MIAMI BEACH

Staff Report & Recommendation

Design Review Board

SUBJECT: DRB19-0373
2726 Alton Road

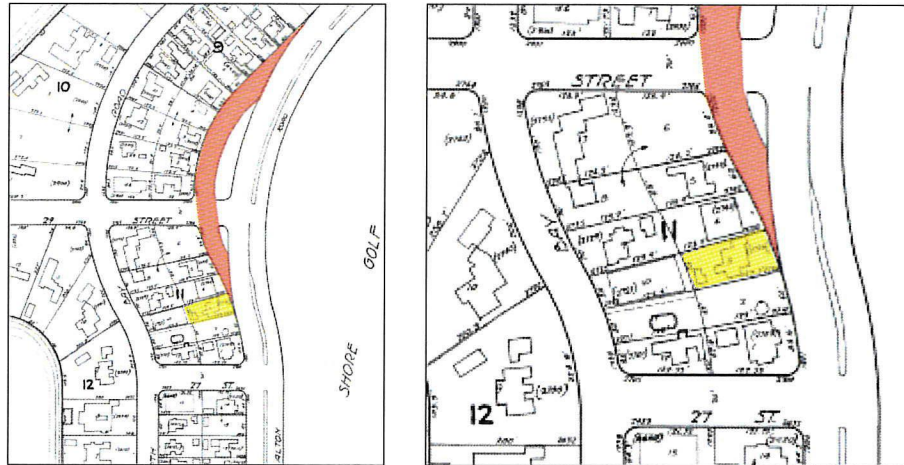
The proposed design consists of a strong defining rectilinear two-story volume with a transparent double height volume offset to the north of the site. On the north side exterior elevation, long linear vertical expanses of fenestration and “simulated wood” framing elements reflect the double height nature of the interior space on the north side elevation. The exterior finish schedule features a one story garage clad with a “stone cladding” broken up with a continuous top transom window facing Alton Road. A large existing mahogany tree is proposed to remain in the city swale.

The one design waiver pertains to the second floor to first floor ratio of the home. Since the proposed home has a lot coverage of nearly 29%, any second floor massing is restricted to 70% of the first floor, unless a waiver is sought by the DRB. The second floor is greater in size and shape to the first floor, primarily due to the cantilevered nature of the second floor in the rear of the residence—this element is hidden from view of the right-of-way. When reviewing the second floor volume rule, staff believes that the greater 2nd to 1st floor ratio request proposed is commensurate with the bold rectilinear style and design of the home. If

the double height living room was reduced to 18'-0" in height, the second floor volume would be reduced to 1,587 SF and the volume would not count towards the second floor volume, reducing the request to 68%. While this effort would have a significant impact on the street view of the residence, the applicant is lowering the height of the massing of the south bedroom wing of the structure in an attempt to rectify this and break up the volume and massing of the residence. Further, the design floor elevation is slightly over the minimum height permitted of BFE +1 freeboard, the rectilinear massing is not exacerbated by the zoning allowances.

Additionally, the 1958 replat of this portion of Alton Road, created a divergent "old Alton Road" for those properties along blocks 9 and 11. This creates a side "access road" for about 14 residences on these two blocks. In the built environment, this translates to a greater swale or setback area from the current Alton Road which minimizes any impact from the true right-of-way. Additionally, the neighboring structure to the south is a three-story residence built in 1926 on a double corner lot property, with its "rear" yard abutting the interior side yard (south) of the subject property. Staff is supportive of the increased second floor ratio waiver; however, should the residence be redesigned at a higher finished floor height or freeboard elevation, staff recommends a return to the Board to reassess the design waiver.

In view of the foregoing analysis, staff recommends the application be **approved**, subject to the conditions enumerated in the attached Draft Order, which address the inconsistencies with the aforementioned Design Review and Sea Level Rise criteria.
